City of Sedona Planning and Zoning Commission Meeting

Staff Report
 PZ18-00001 (SUB)
 Habitat for Humanity Triplex
 Summary Sheet

East Sedona Water Storage Tank, Booster Pump Station and Related Appurtenances Conditional Use Permit Package April 2018

DRAWING NO.
PP1

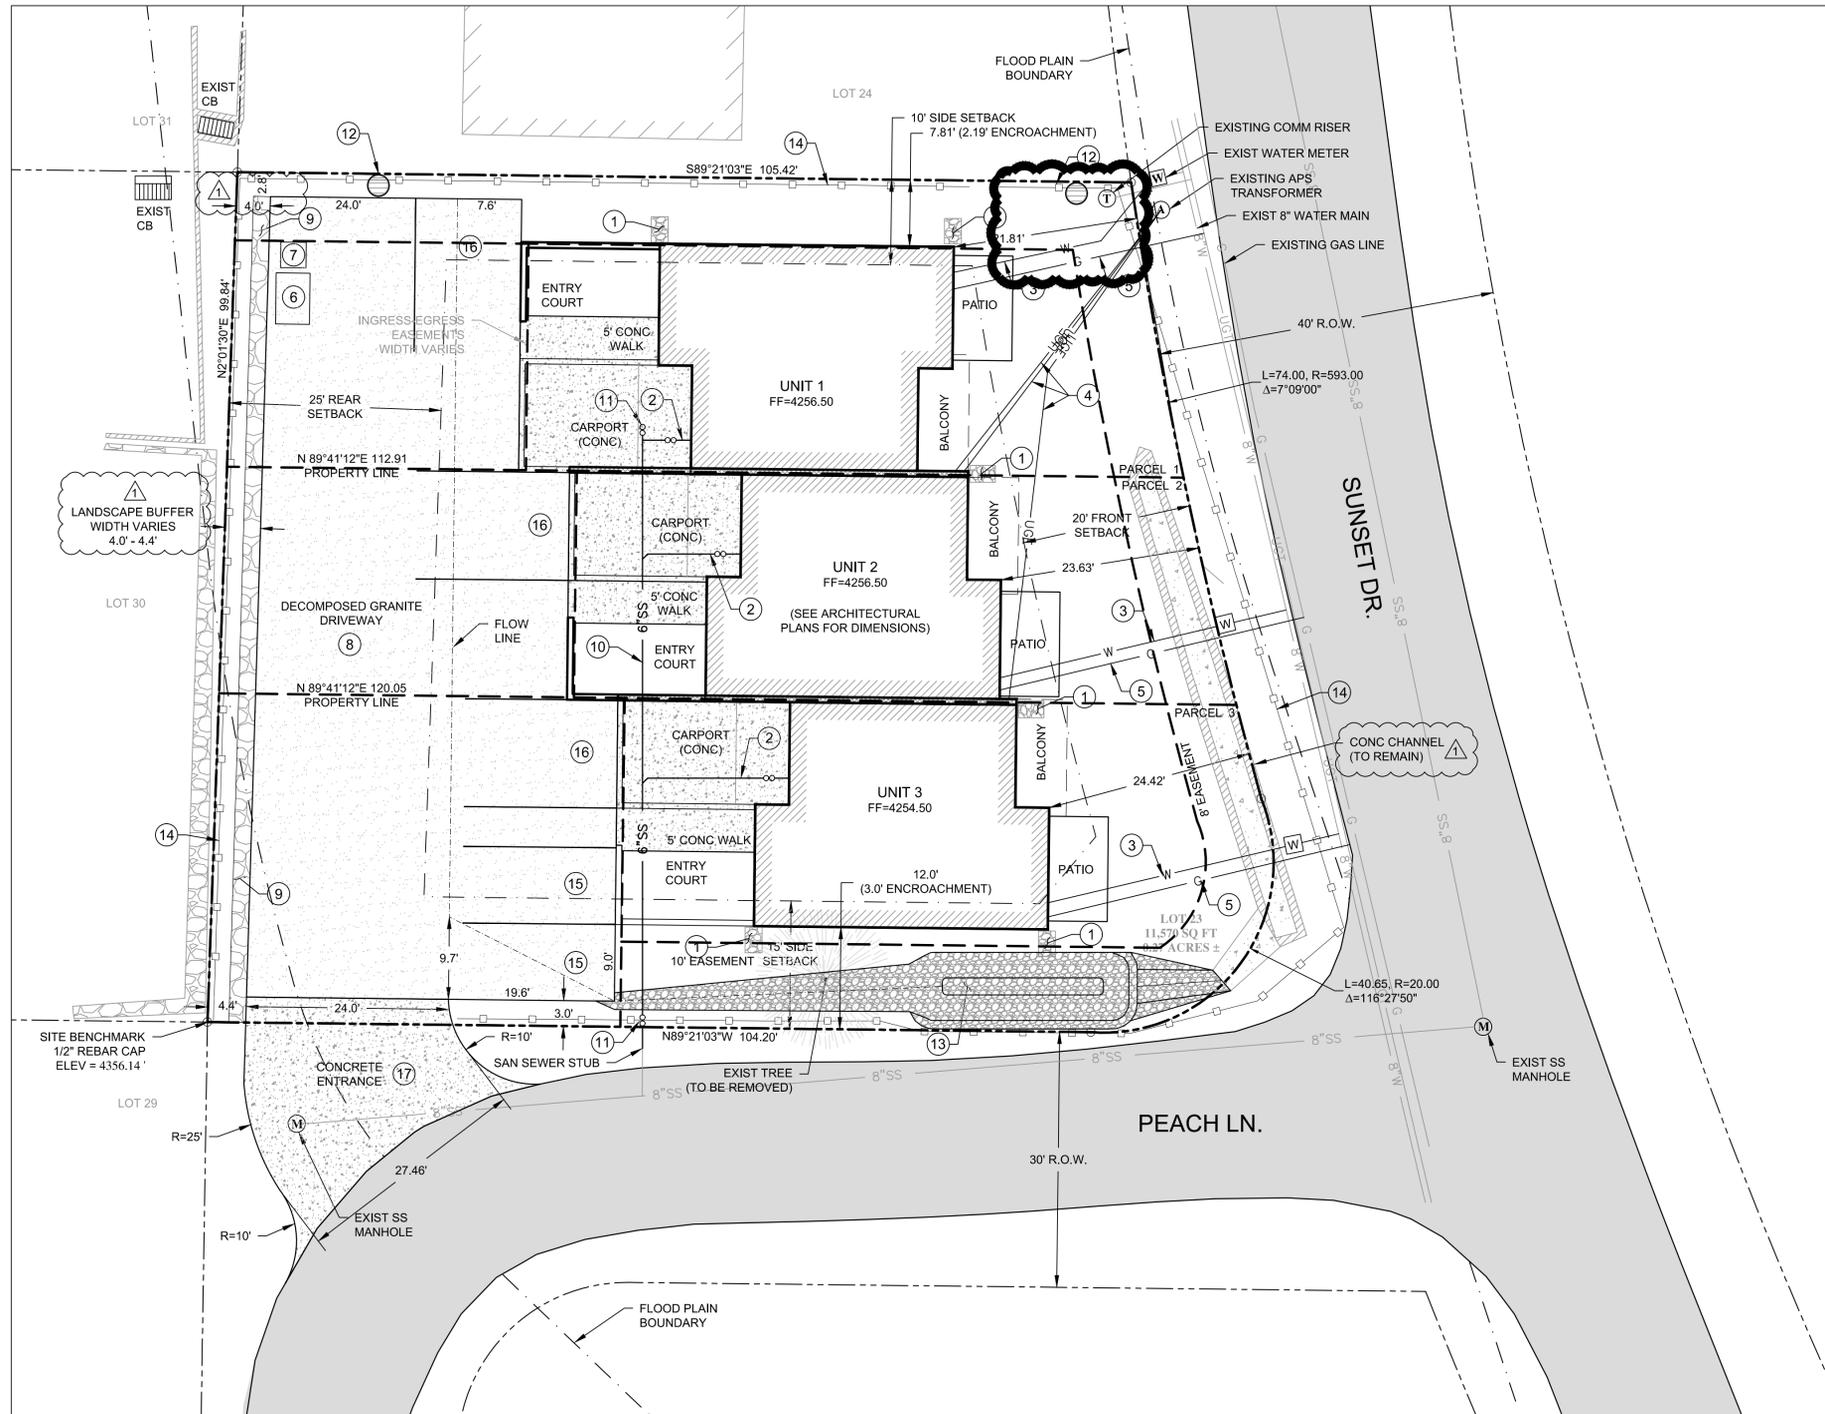
2. The note on the Preliminary Plat that calls out the "Proposed Ingress-Egress Easement" shall be amended to remove "To be granted to the City of Sedona on Final Plat".

3. All elevation call outs on the Preliminary Plat shall be amended to reflect the correct elevations, beginning with 43XX rather than 45XX.
4. The proposed driveway easement has a variable width, and as such the width shall be notated on the plat.

5. The name of the subdivision on the title block of the Preliminary Plat shall be amended to read the correct name of the subdivision, the "Cottages at Peach Lane".

DATE: JULY 2018
PROJECT NUMBER: 16-029
DRAWING NUMBER: C-101
SHEET: - OF -

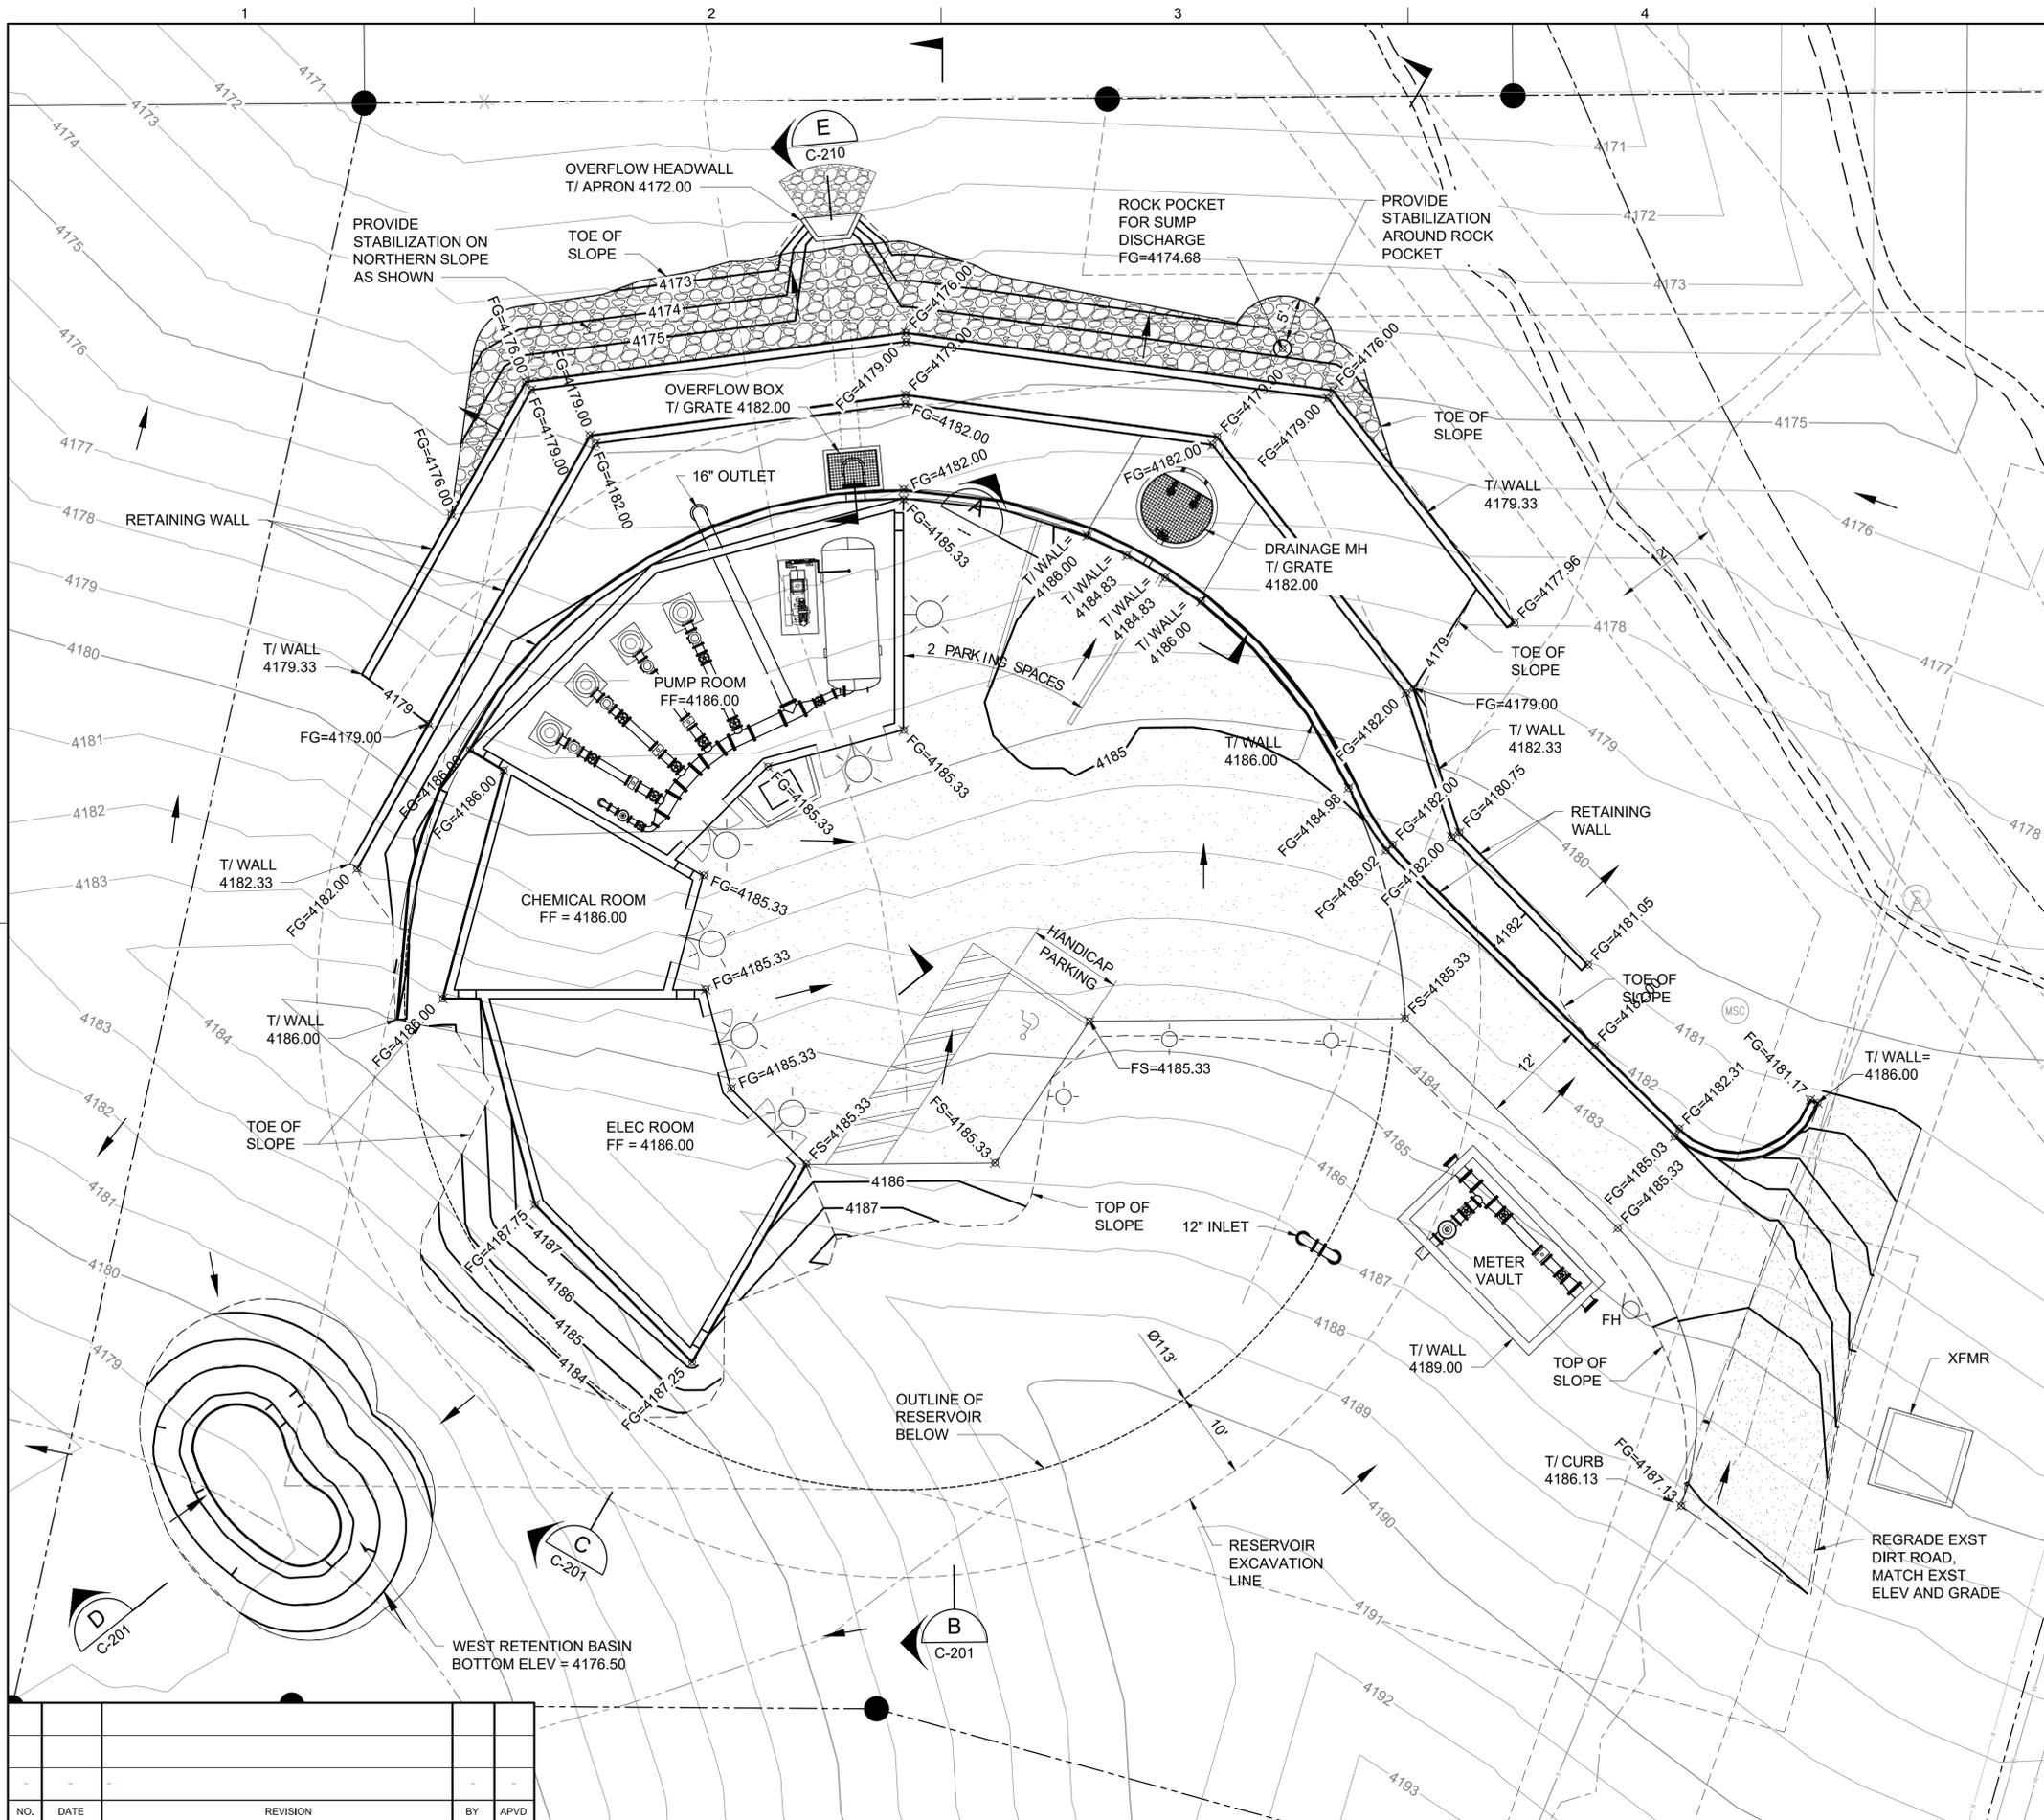
2. On sheet C-101, please add the section E onto the plan.

3. On sheet C-101, please label all contours and differentiate major from minor contours and improve the differentiation of the proposed vs existing contours.

3. Please show the existing roadway on sheet C-101.
4. Please delineate the 100-yr flood plain on sheet G-104.
5. Stormwater storage shall have a principal outlet of 12" diameter.

Response – In the area over the sewer line that will be impacted by the project, the cover will be increased between 6"-12". The manhole area will not be impacted by this project. A note has been added on Drawing C-101 to require the Contractor to adjust the Manhole cover as required.

Response – Roadway design has been modified to maintain existing contours as much as possible. Slope stabilization has been added as shown on Drawing C-101.

Response – Slope stabilization has been added. Refer to Drawing C-101.

Response – Outlet erosion protection is added for the rock pocket outlet. Refer to Drawing C-101.

Response – Drain time has been added on Drawing C-101.

Response – Floodplain boundaries are shown on Drawing C-101.

Response – Flow through drainage is provided – see revised Drawing C-101.

E SECTION
C-101 1" = 10'

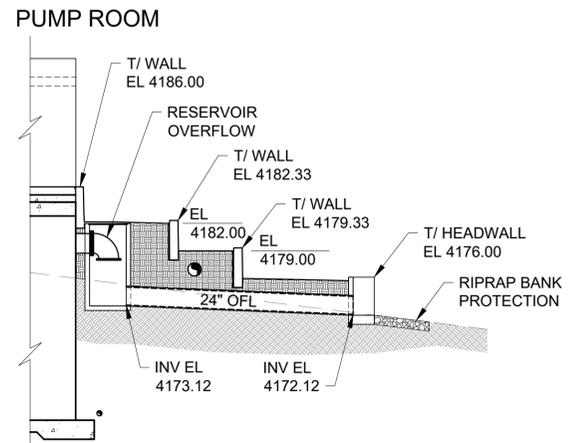
8. On sheet C-201, section E, the 24" OFL is shown uncovered, please provide fill cover for the entire pipe.

Response – Overflow pipe has been shortened and fully covered as shown on Drawing C-201.
